DECLARATION OF JOHN LARGE
IN SUPPORT OF 2.206 PETITION
BY FRIENDS OF THE EARTH

- i) **ROOT CAUSE ANALYSIS REPORT FOR TUBE WEAR IDENTIFIED IN THE UNIT 2 AND UNIT 3 STEAM GENERATORS OF SAN ONOFRE NUCLEAR GENERATING STATION - UES-20120254 REV.0 (3/64), C OCTOBER 2013**
- ii) **SUPPLEMENTAL TECHNICAL EVALUATION REPORT, L5-04GA588(0), C JANUARY 2013**
- iii) **E BAUMGARTNER, MHI LETTER TO A T HOWELL, NRC OF FEBRUARY 25, 2013**
- iv) **RESPONSE OF SOUTHERN CALIFORNIA EDISON TO MOTION OF FRIENDS OF THE EARTH AND WORLD BUSINESS ACADEMY FOR EXPEDITED CONSIDERATION OF CERTAIN PHASE III ISSUES, BEFORE PUBLIC UTILITIES COMMISSION OF CALIFORNIA, 12-10-013 MARCH 22, 2013**

**TUBE WEAR IDENTIFIED IN THE SAN ONOFRE REPLACEMENT STEAM GENERATORS
MITSUBISHI REPORTS UES-20120254 REV.0 (3/64) AND L5-04GA588(0) TOGETHER WITH
OTHER RELEVANT INFORMATION**

FIGURE 1 AVB DESIGN ARRANGEMENTS ACCORDING TO THE CERTIFIED CONTRACT SPECIFICATION

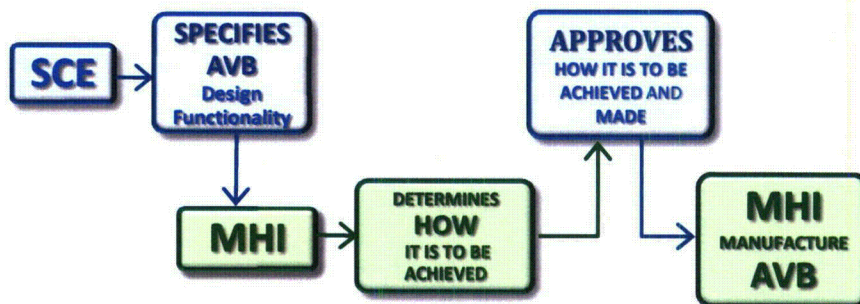
The *Certified Design Specification* (CDS - see 3.10.3.5 extract above) is quite clear with, at the pre-design contract stage, SCE specified both:

- a) the underlying type of AVB restraint (*zero tube-to-flat bar gap*) which, because the gap is specified (*0.003"*), can only mean that there was to be no contact pre-load force and, hence, no friction force restraining tube motion in the IP direction; and
- b) that this design objective should apply in the OOP (*out-of-plane*) direction, at the disregard of tube motion in the IP direction.

FIGURE 2 ARRANGEMENTS ACCORDING RCA SCE/MHI COMBINED AVB DESIGN TEAM SPECIFICATION

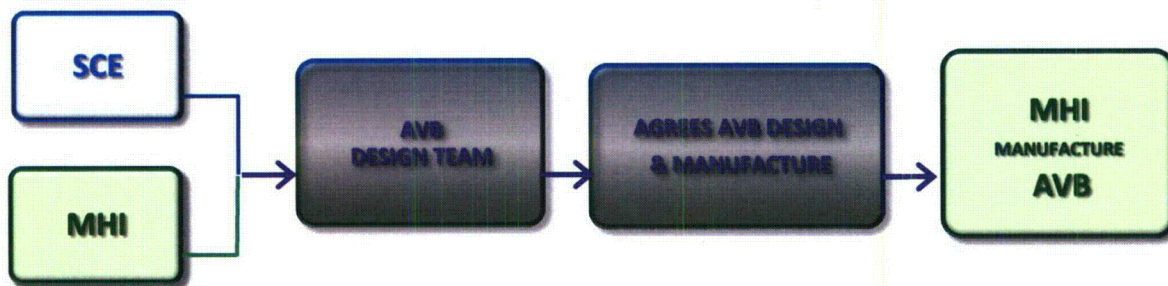
Interpretation of these arrangements suggests that SCE had much hands-on involvement with decisions relating to the detailed design and manufacture of the AVB. In this joint role SCE was involved at all stages of the design that arrived and approved the incorrect design option for the AVB restraint and, moreover, it was also involved in the flawed method of manufacture which resulted in warped AVB bars that were subsequently corrected for the later manufactured Unit 3 RSGs (incidentally, reducing the quite fortuitous pre-loading of some of the AVB-to-tube contact points that were, as it transpired to be, the most obvious reason for the delay the onset of TTW in Unit 2).

DIAGRAM 1 TIMELINES FOR SELECTED DESIGN ACTIVITY TOPICS

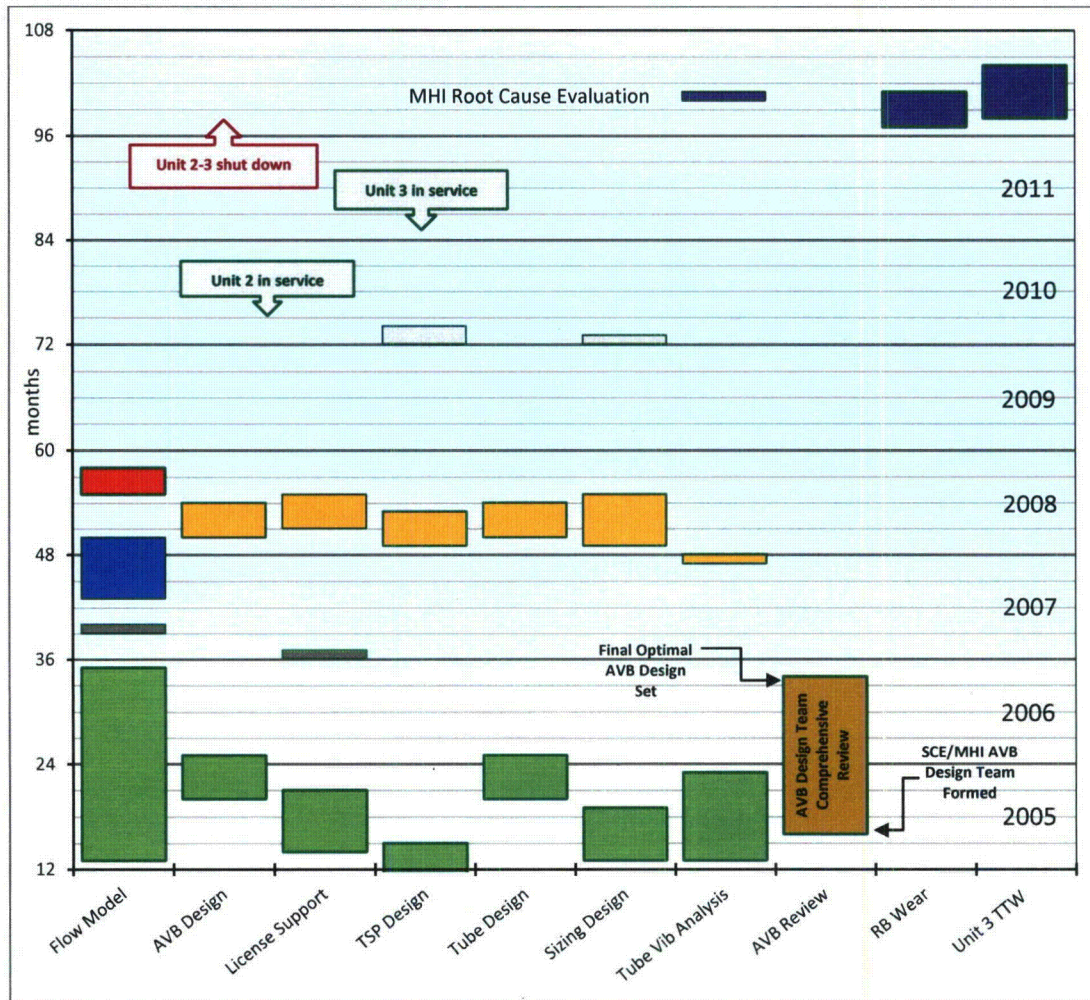
As evident from **DIAGRAM 1**, most of the design activity ■ seems to have been settled by 2005 to late 2006. Note that the critical topics *AVB Design* and *Review*, and *Tube Vibration Analysis* seem to have been closed out early in 2005-06, although the flow modeling continues through with revisions being raised through to late 2008.
